**To:** Bassett Creek Watershed Management Commission  
**From:** Barr Engineering Co.  
**Subject:** Item 6Ai – Agora Development – Plymouth, MN  
BCWMC February 16, 2017 Meeting Agenda  
**Date:** February 8, 2017  
**Project:** 23270051 2017 2108

### 6Ai Agora Development–Plymouth, MN BCWMC 2017-01

**Proposed Work:** Redevelopment of the Four Seasons Mall site in Plymouth, MN.

**Recommendation:** Conditional Approval

**PRO-DA MAP**

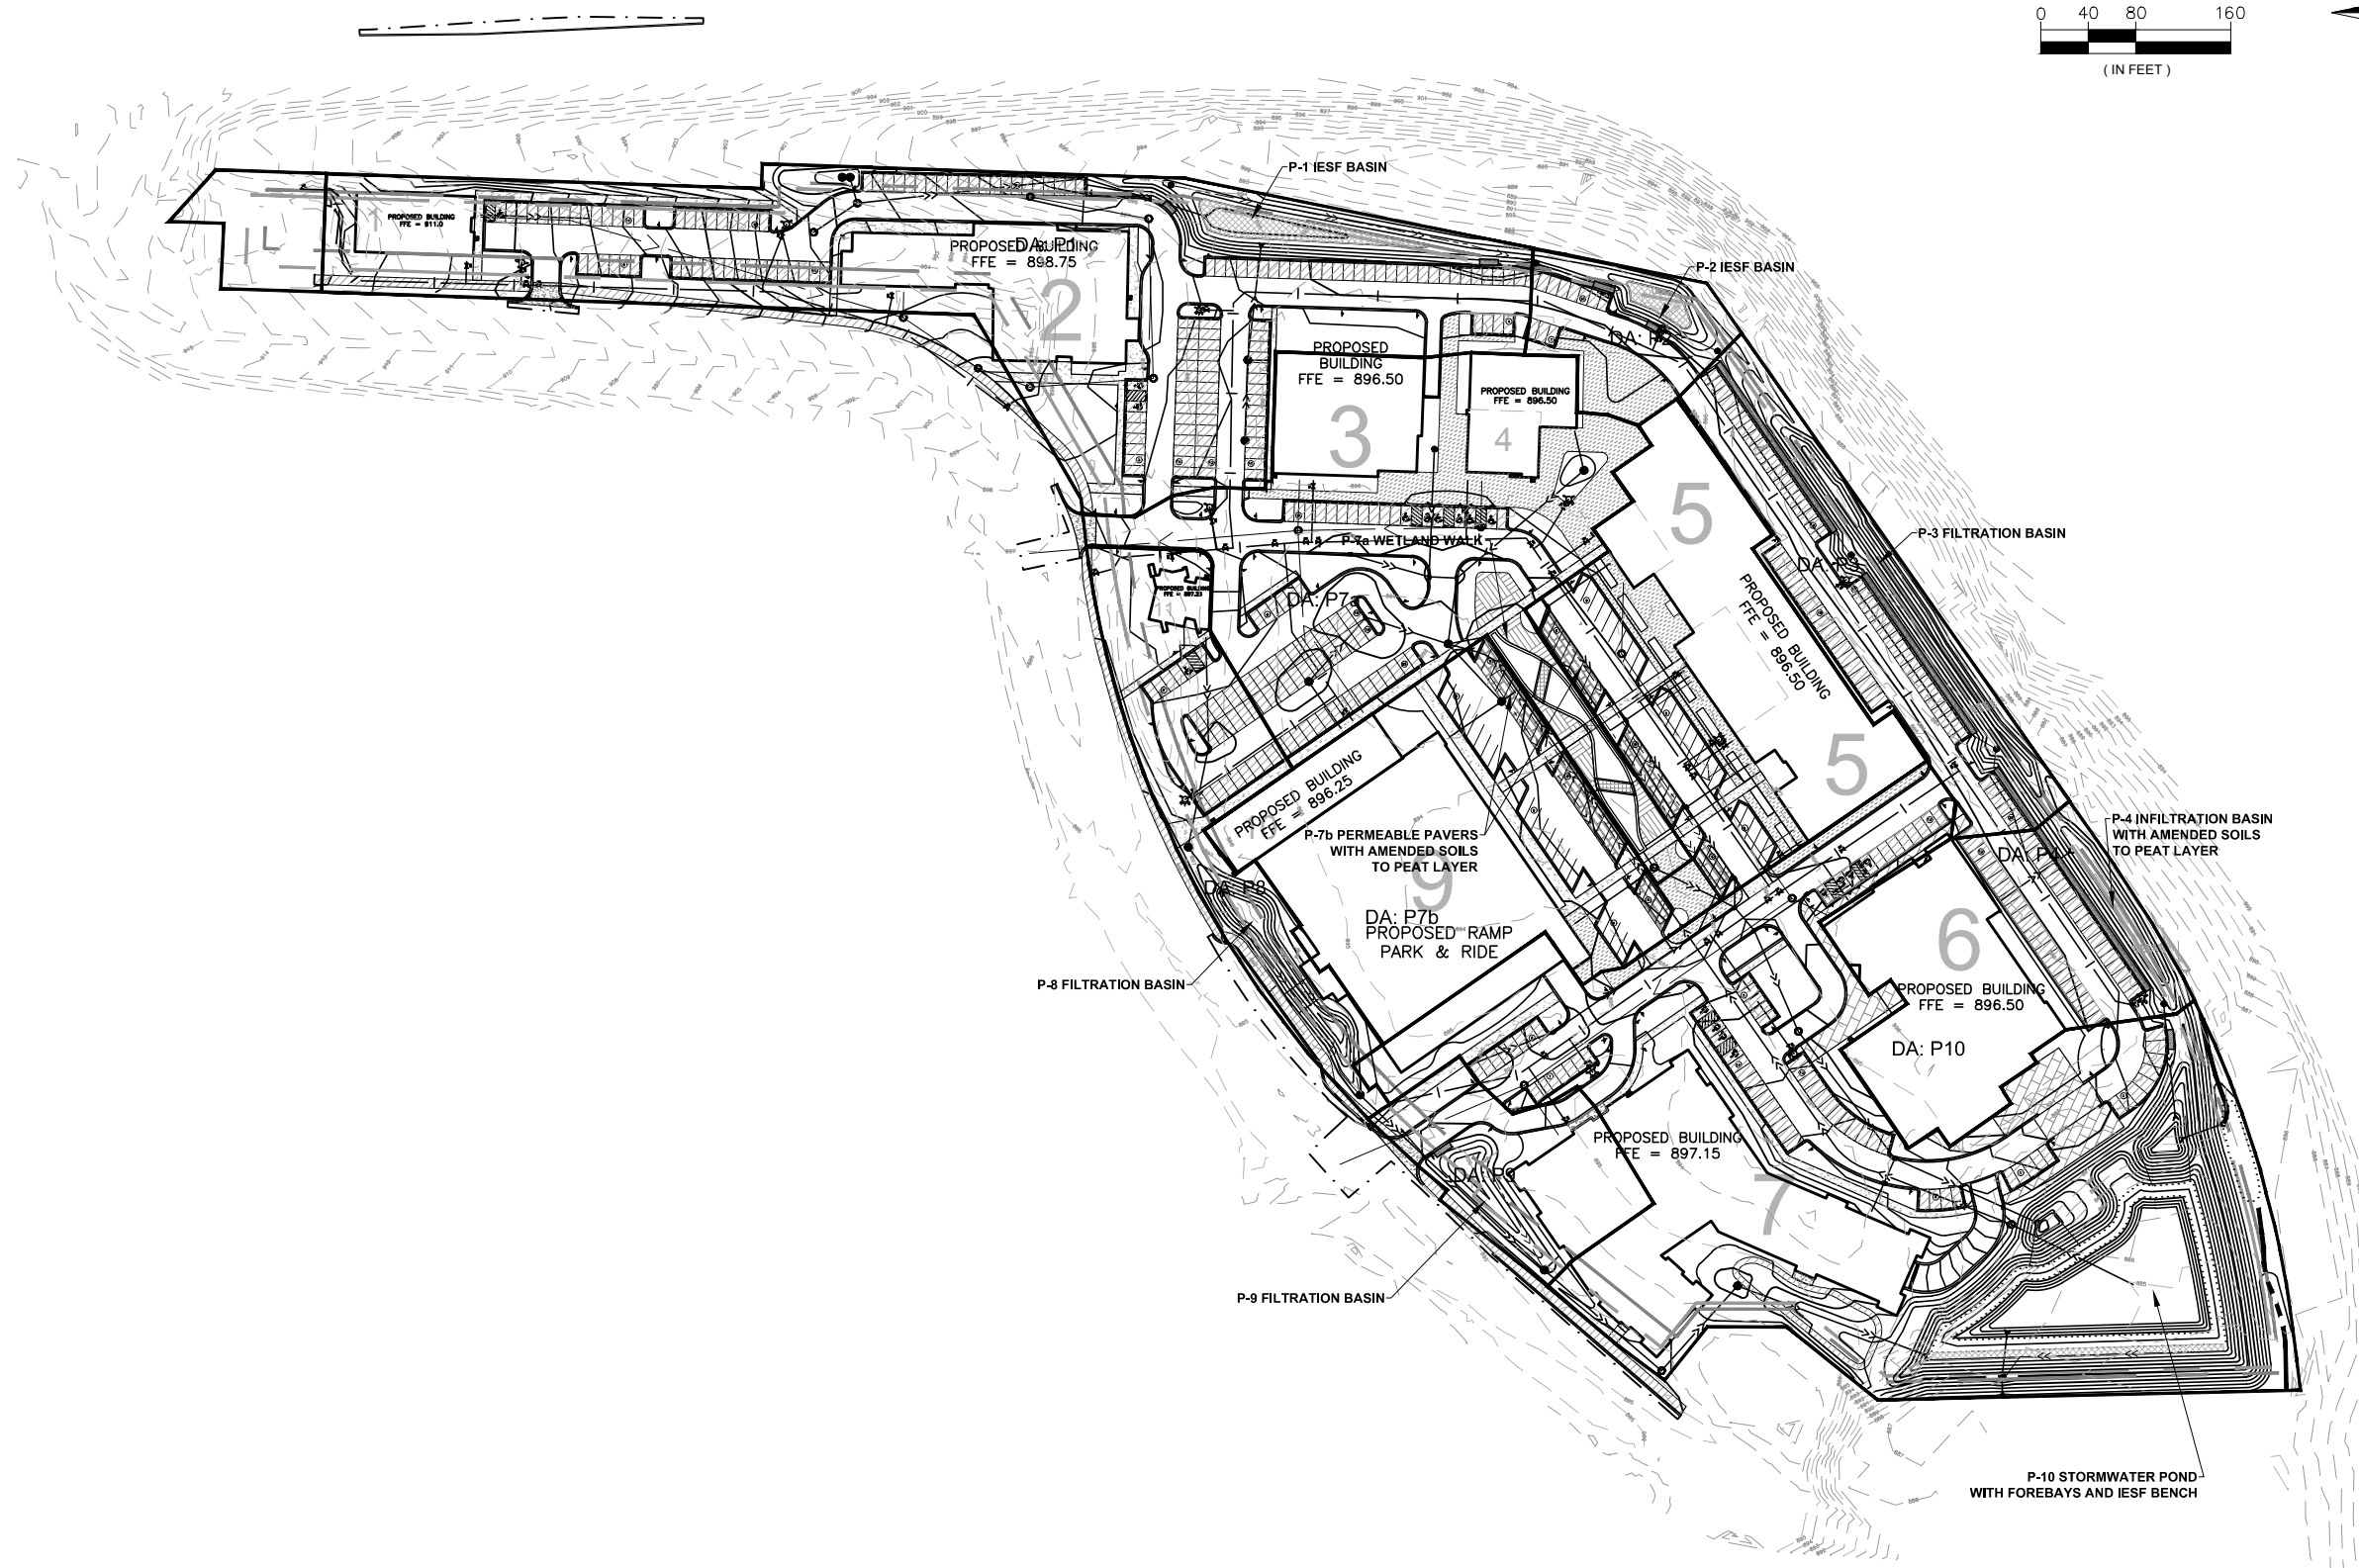
3. The applicant must clarify how the flow path for the Bassett Creek North Branch will be handled/changed as a result of the project. The North Branch appears to flow through the area that will be converted to a pond. Rerouting the creek will likely require a permit from the DNR because the North Branch is a DNR public watercourse.

5. Offsite drainage must be accounted for in the existing and proposed conditions HydroCAD models. The modeling must demonstrate that the proposed project does not increase discharge rates.

6. While rate control is not required for offsite runoff which flows onto the project site, the proposed stormwater BMPs must be adequately designed to handle runoff from their respective drainage areas, which may include offsite runoff.

7. BMP storage volumes are not consistent between the HydroCAD model and MIDS model. Models must be modified accordingly or provide justification for the discrepancies.

8. Some permeable paver areas drain to the wetland walk area, while other permeable paver areas drain directly to the stormwater pond. This is not reflected in the HydroCAD or MIDS modeling. Models must be modified to represent the proposed conditions or justification provided for the current methodology.

9. In the proposed conditions MIDS model, an underground infiltration BMP is used to represent permeable pavers instead of a permeable pavement BMP. This methodology claims 100% volume reduction and 99% nutrient removal. Modify the model to represent the proposed BMP as permeable pavement or provide justification for the current methodology.

10. The "Proposed with Additional BMPs and Off-site Drainage" MIDS model and the "Loading from Off-site (North)" MIDS model are inconsistent with their soil types. Please clarify the hydrologic soil group (HSG) for the off-site drainage areas.

The provided MIDS model and Stormwater Management Plan indicate that the pervious pavers receive runoff from permeable surfaces and that the drainage area to surface area ratio exceeds 5:1. Modification of the pervious paver design to meet the recommendations of the Minnesota Stormwater Manual is recommended.

12. Documentation must be provided to demonstrate that the flow path length to pond width ratio is at least 1.5:1 for the proposed stormwater pond, as is required for a Minnesota Stormwater Manual stormwater pond design level 3.

13. The proposed stormwater pond design does not appear to have sufficient permanent pool volume (57,078 cf required based on 31.7 acre drainage area; 55,229 cf provided). The proposed stormwater pond must be revised to provide adequate storage to meet the Minnesota Stormwater Manual’s requirements for a stormwater pond.
